MILITARY SPECIFICATION

SAFETY AND ARMING DEVICE, GUIDED MISSILE: M114
LOADING, ASSEMBLING AND PACKING

This Amendment forms a part of Military Specification MIL-S-14799B (AR) dated 4 September 1973, and is approved for use within the U.S. Army Armament, Munitions and Chemical Command and is available for use by all Departments and Agencies of the Department of Defense.

Figure 1

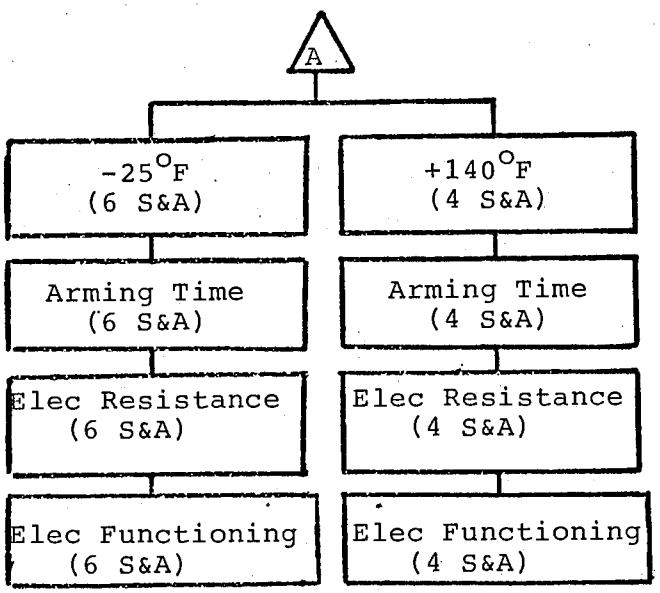
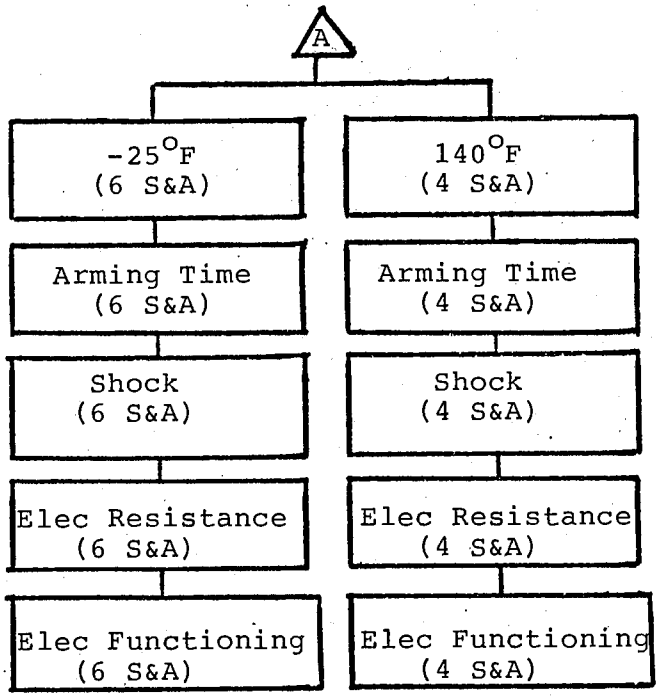
Figure 1 change,

From:

To:

Figure 2

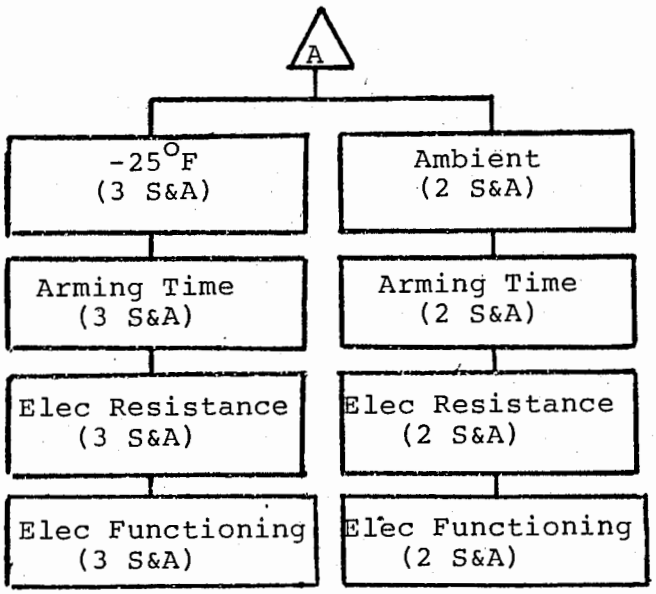
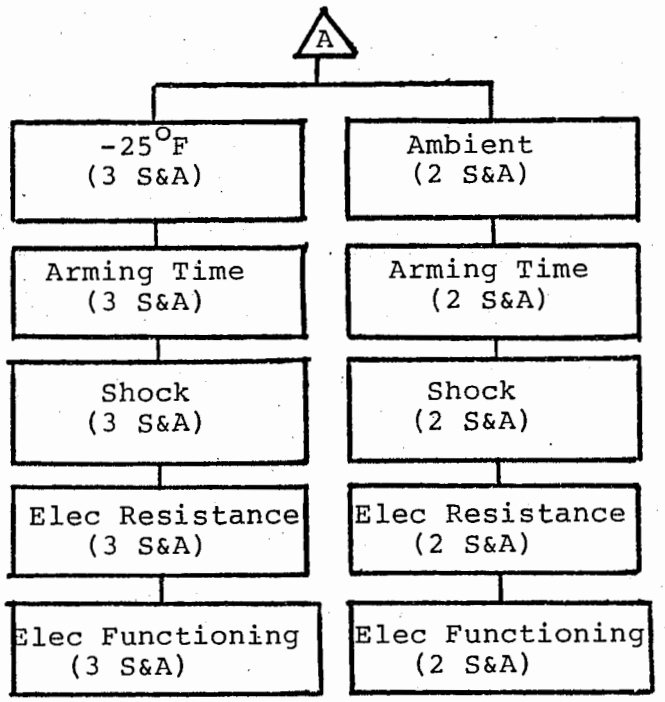
Figure 2 change,

From:

To:

Figure 3

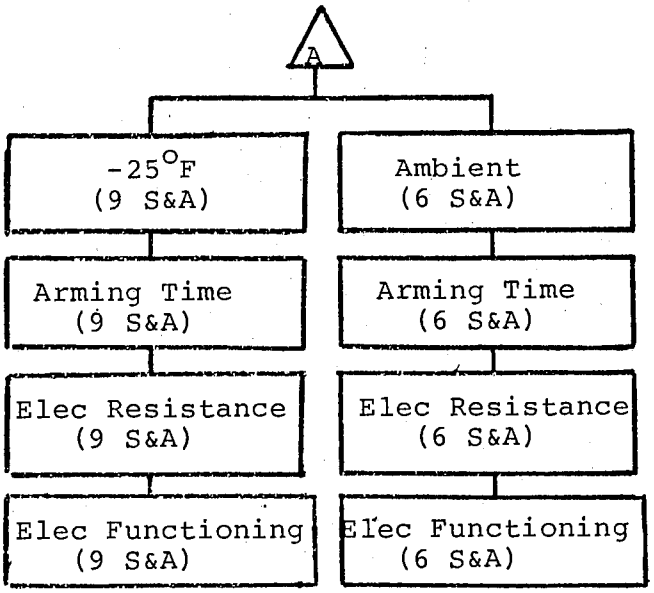
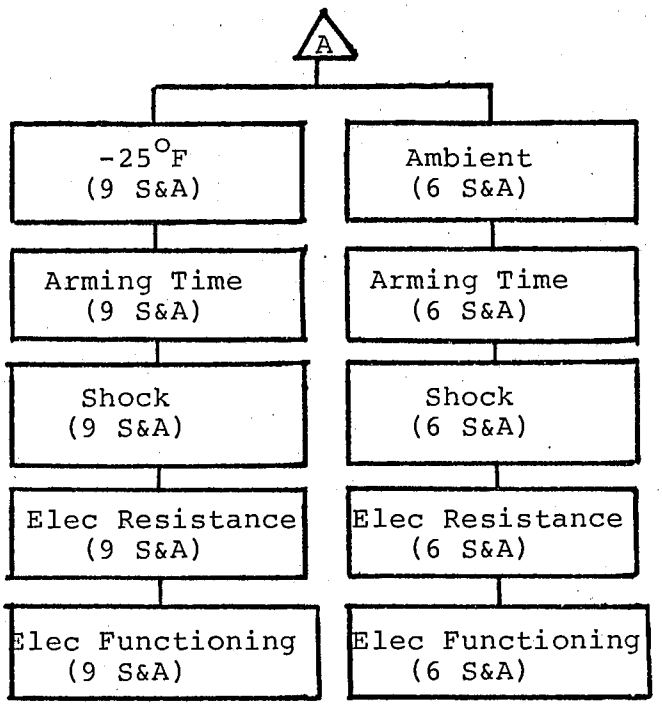
Figure 3 change,

From:

To:

Figure 4

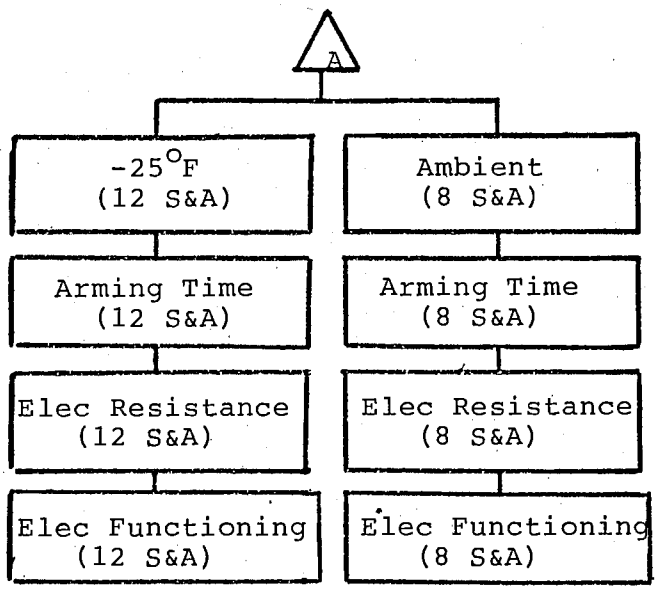
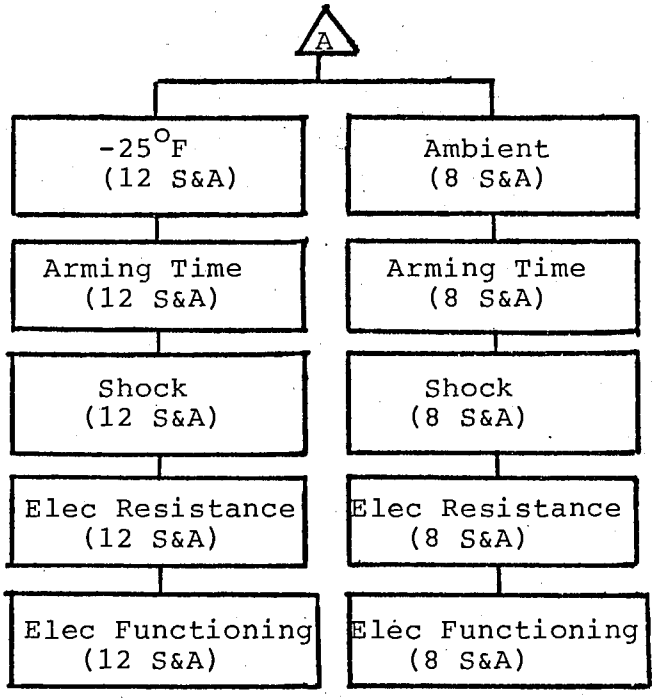
Figure 4 change,

From:

To:

Figure 5

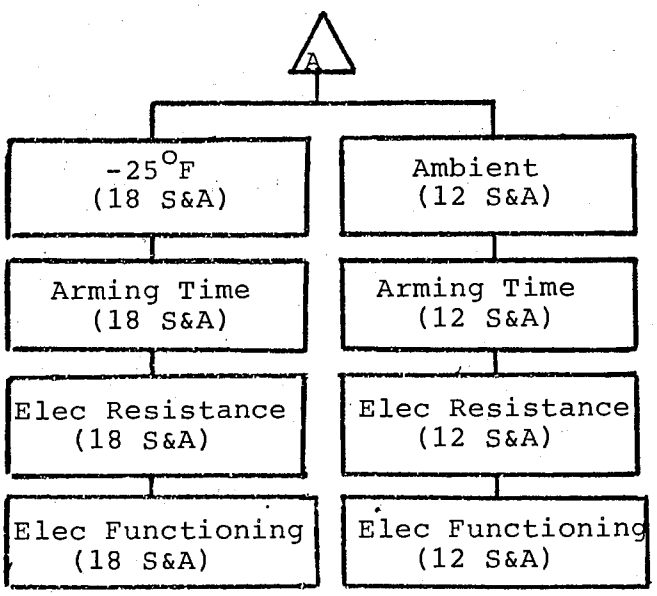
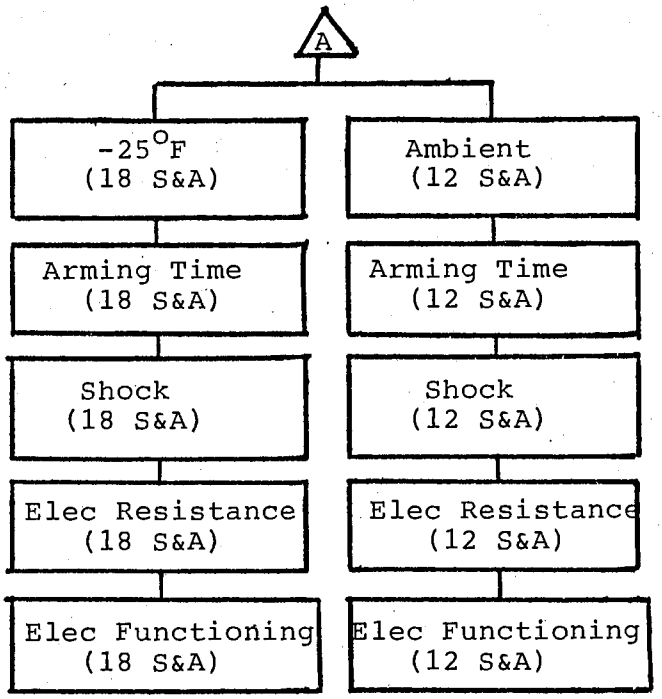
Figure 5 change,

From:

To:
